SUBJECT: Contract 008066
SR 520 Floating Bridge and Landings Project
Federal Aid No.: BR-0520(047)
Change Order No. 195 – Unit Price Reconciliation

**WASHINGTON STATE
DEPARTMENT OF TRANSPORTATION
CHANGE ORDER**

CONTRACT NO: 008066 FEDERAL AID NO: BR-0520 (047)
 CONTRACT TITLE: SR 520 / I-5 TO MEDINA - EVERGREEN POINT FLOATING
 CHANGE ORDER NO: 195 RECONCILE CO 108 ITEMS

FIGURE 1 PONTON T KEEL FRP PLAN
 SCALE: 1/32" = 1'-0"

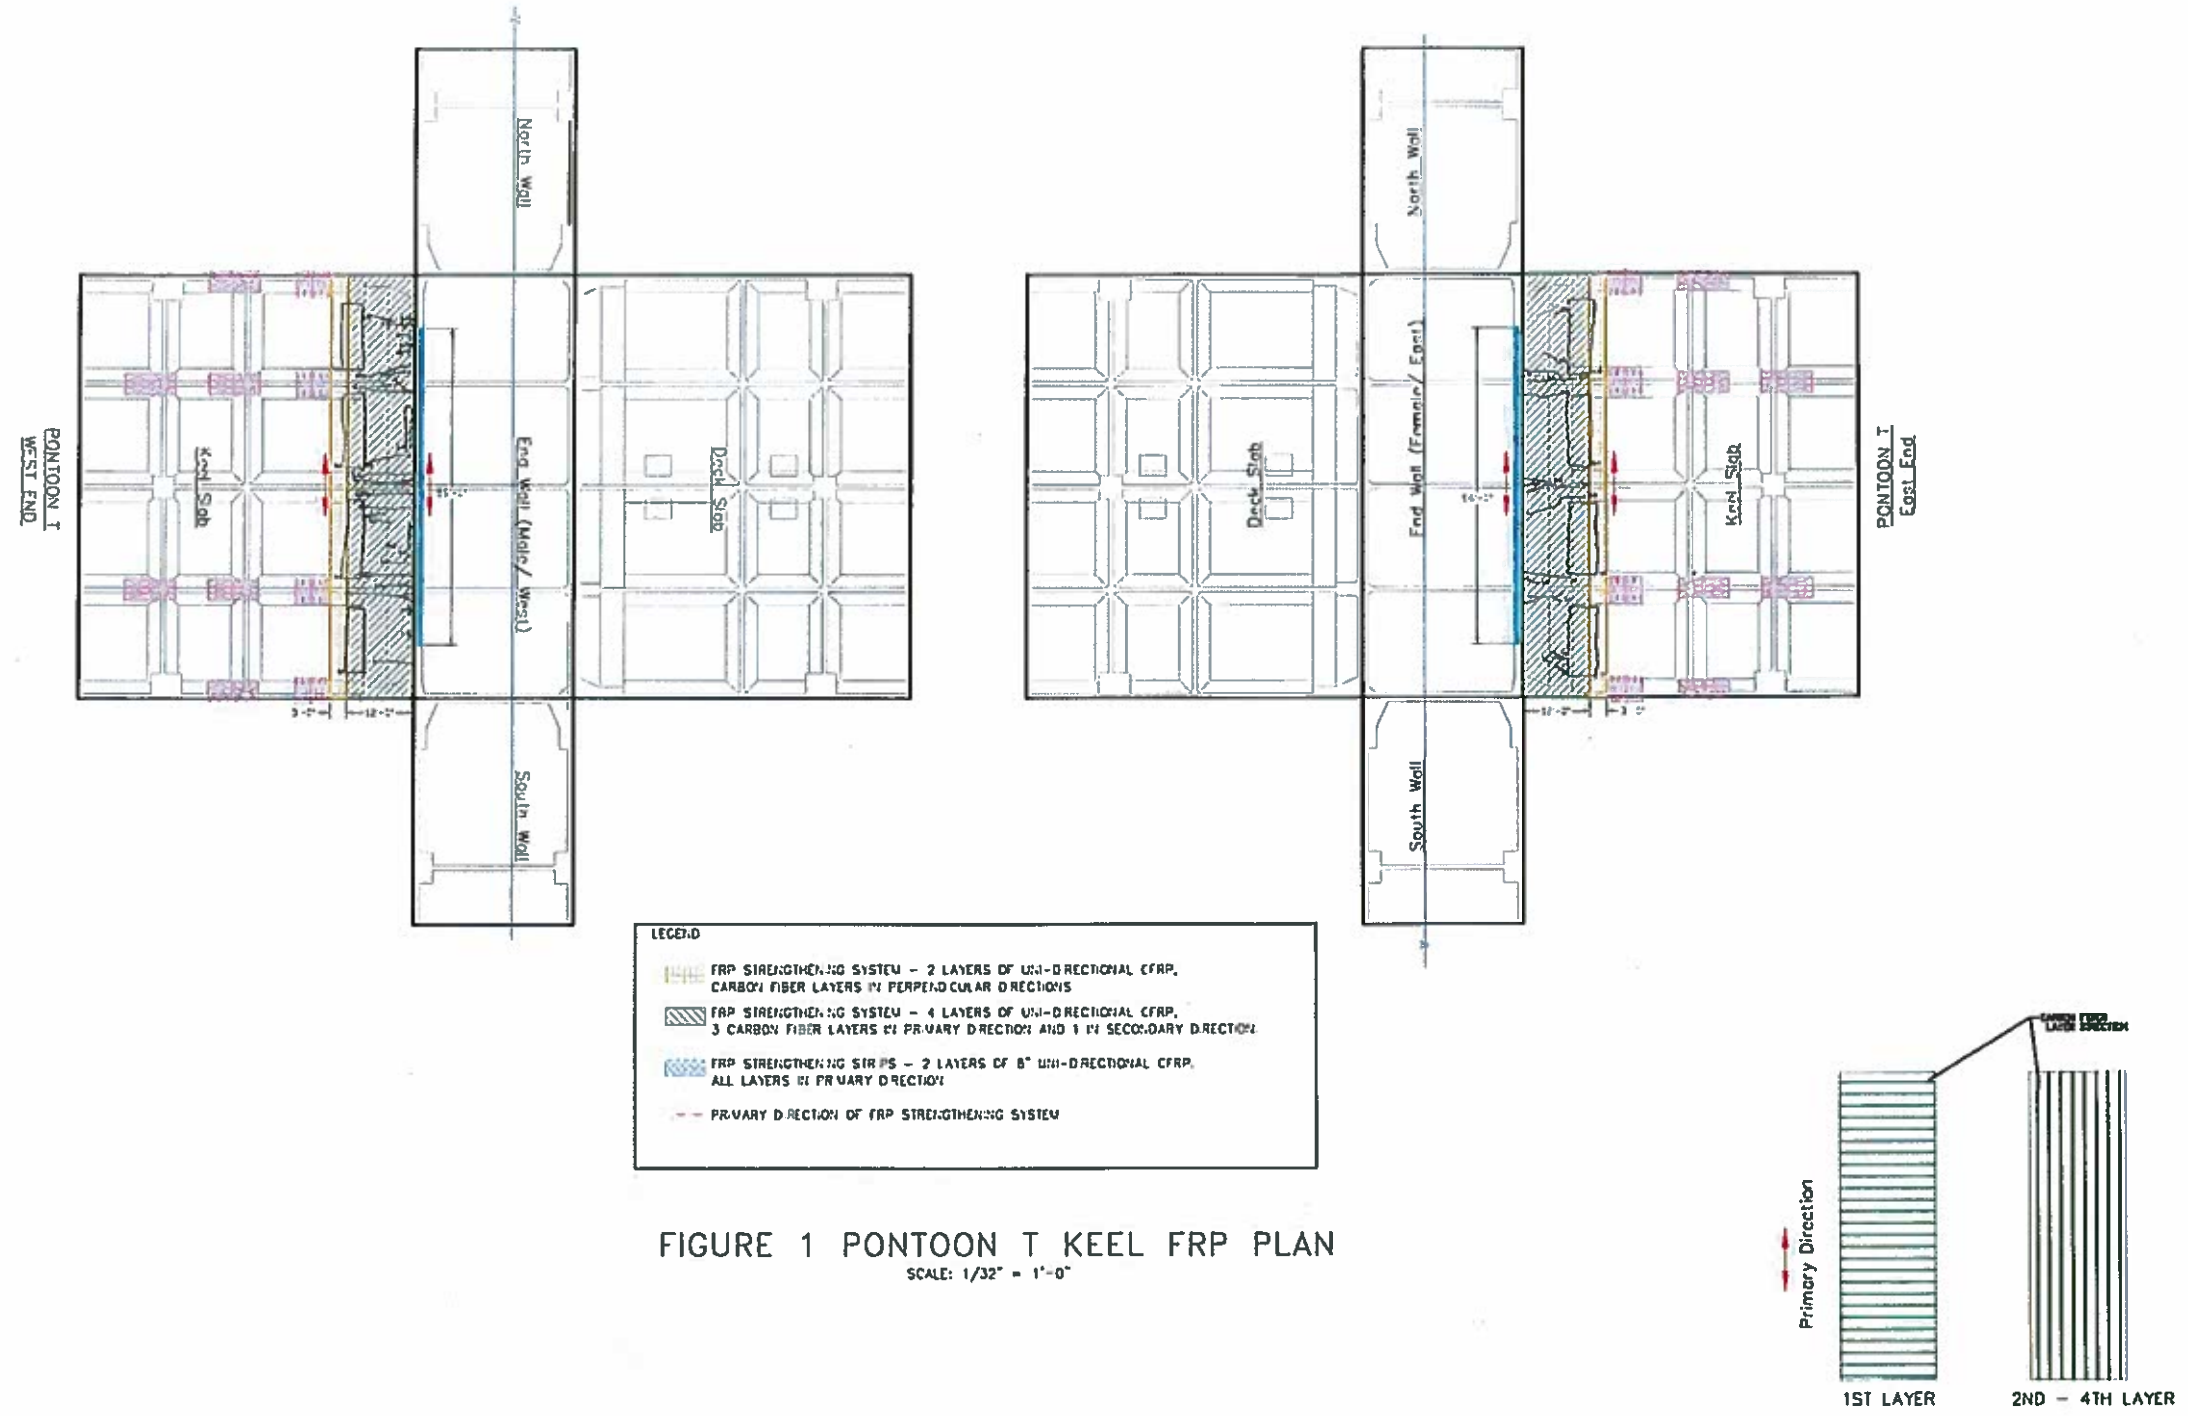
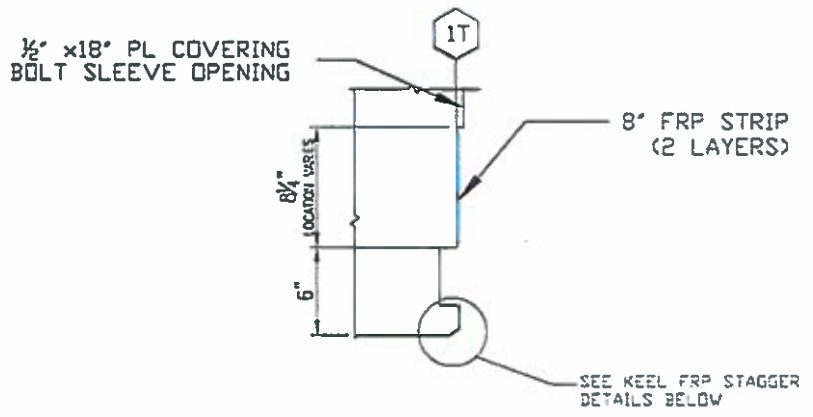
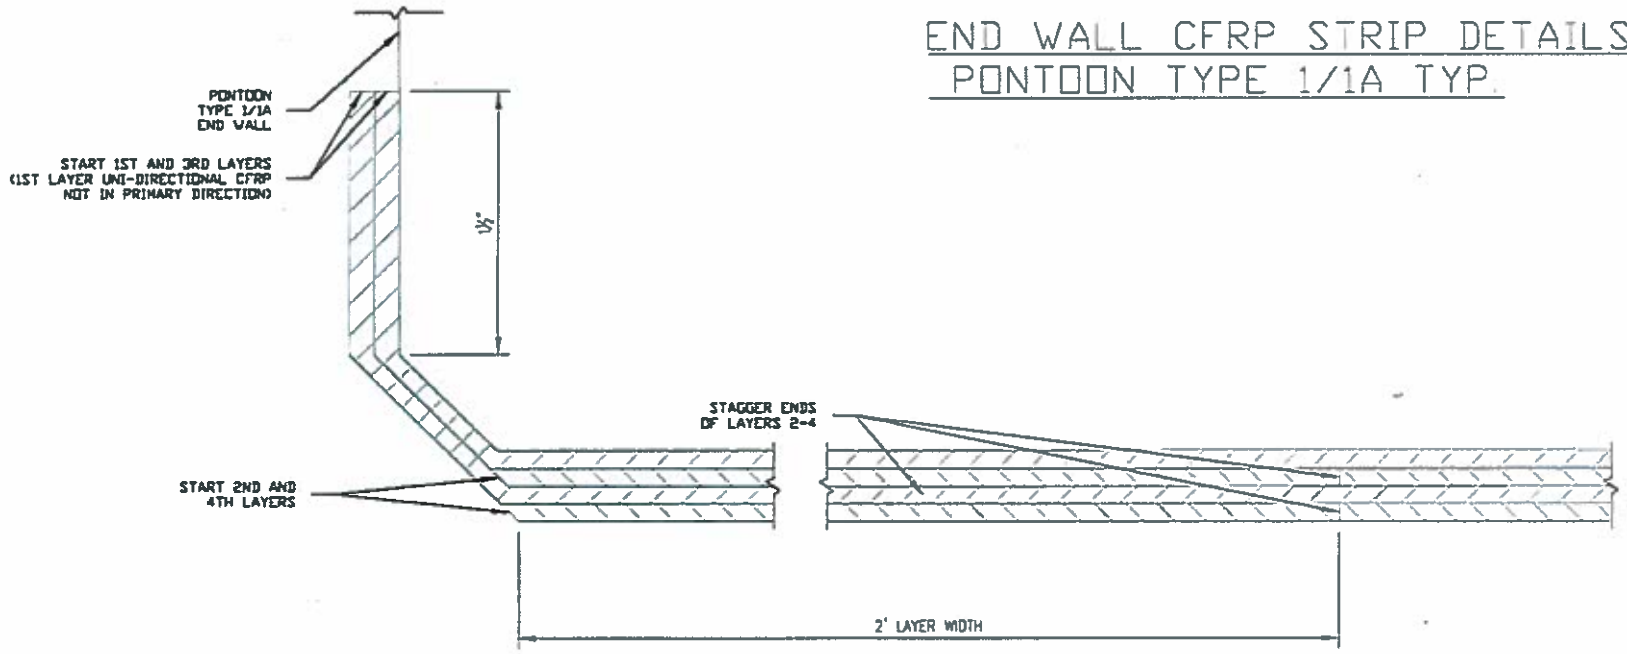
- * Pontoon T The application of the CFRP systems shall be as shown on pages 5 and 6 of this change order.

FIGURE 1 PONTON V FRP PLAN (EAST END)

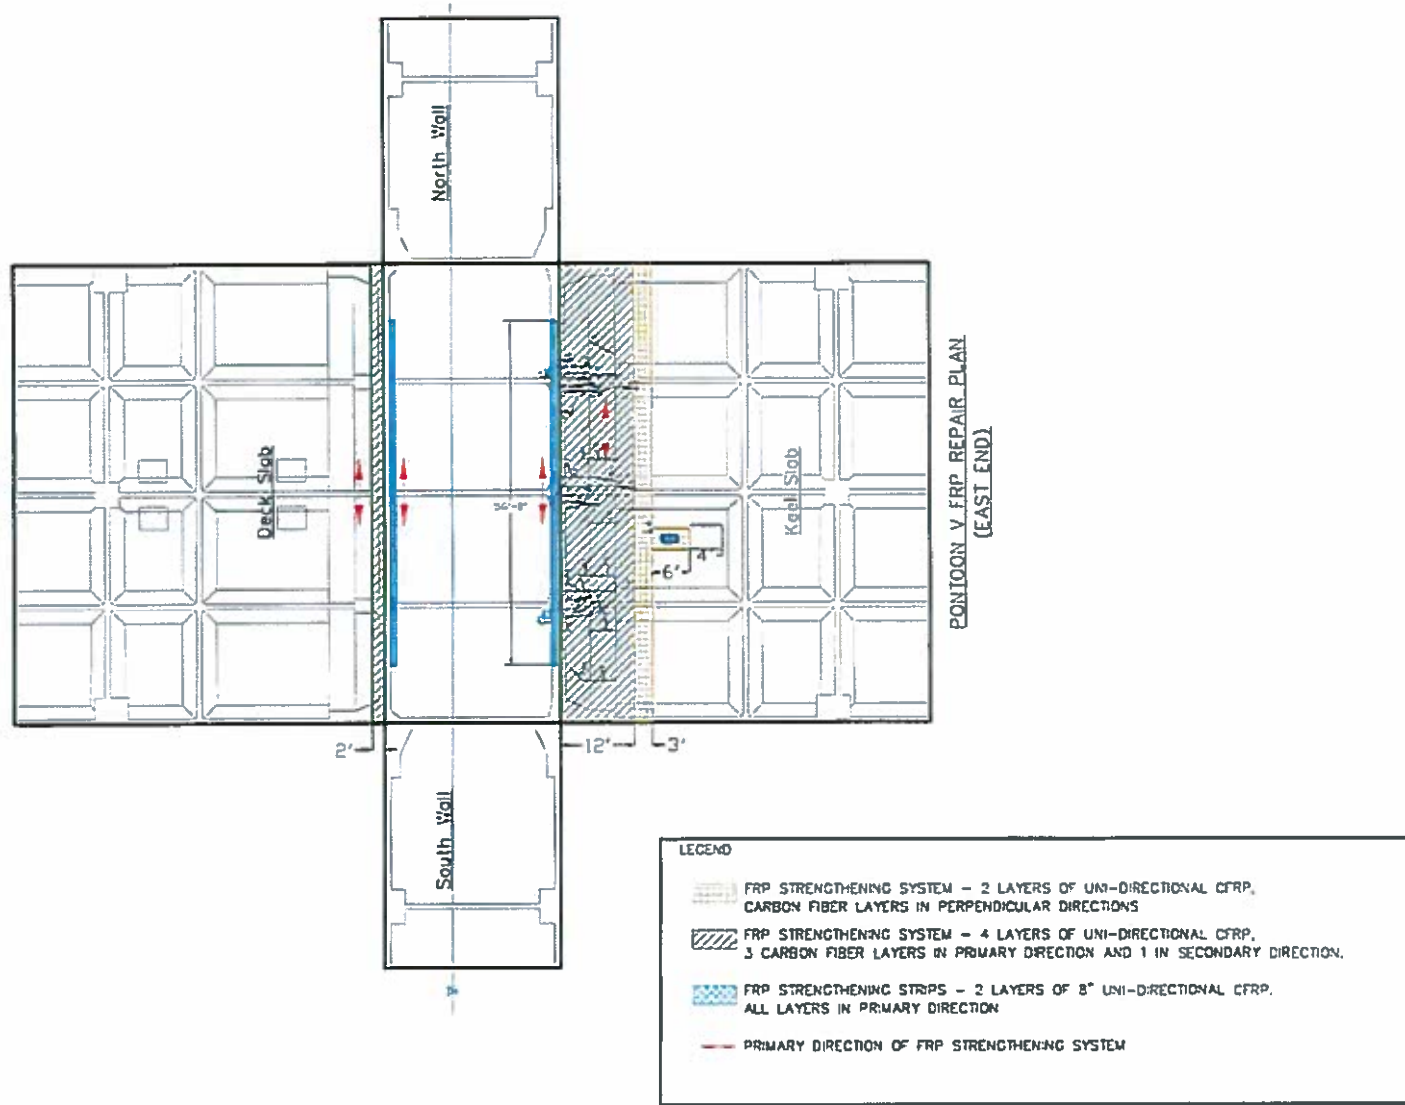
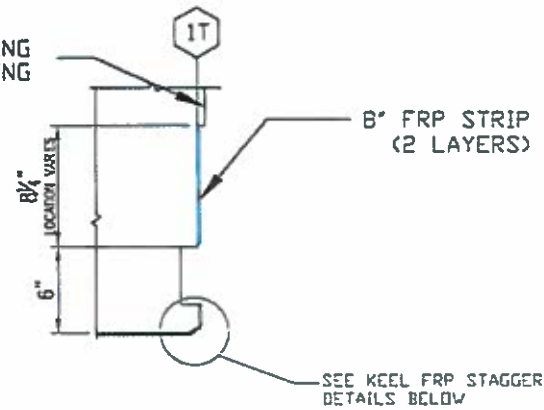
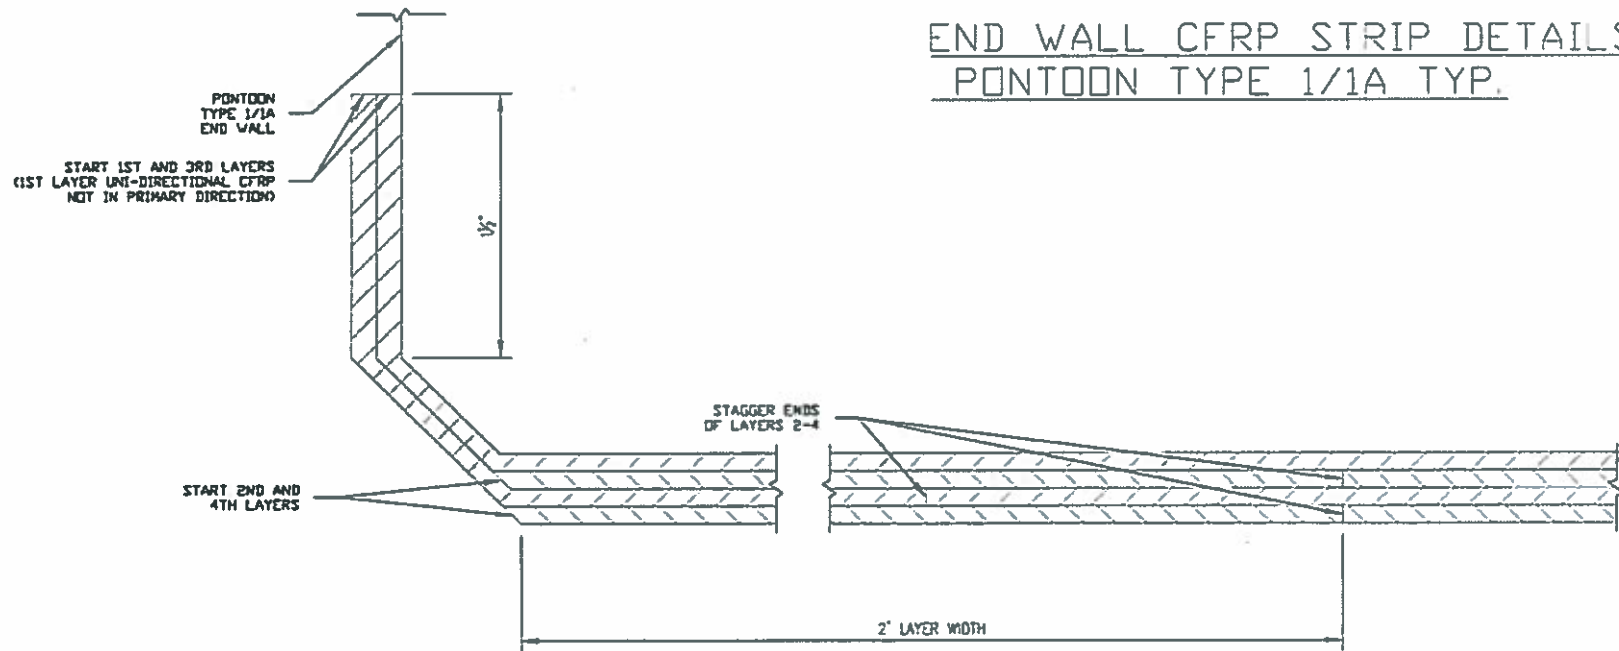
- * Pontoon U - The application of the CFRP systems shall be similar to Pontoon V as shown on pages 7 through 9 of this change order.
- * Pontoon V - The CFRP system application areas shown on pages 102 and 103 of Change Order No. 108 shall be replaced by the areas shown on pages 7 through 9 of this change order. The direction and number of layers installed shall be as identified in this change order.
- * Pontoon W A 3-layer CFRP system shall be applied to the deck slab as shown on page 10 of this change order.
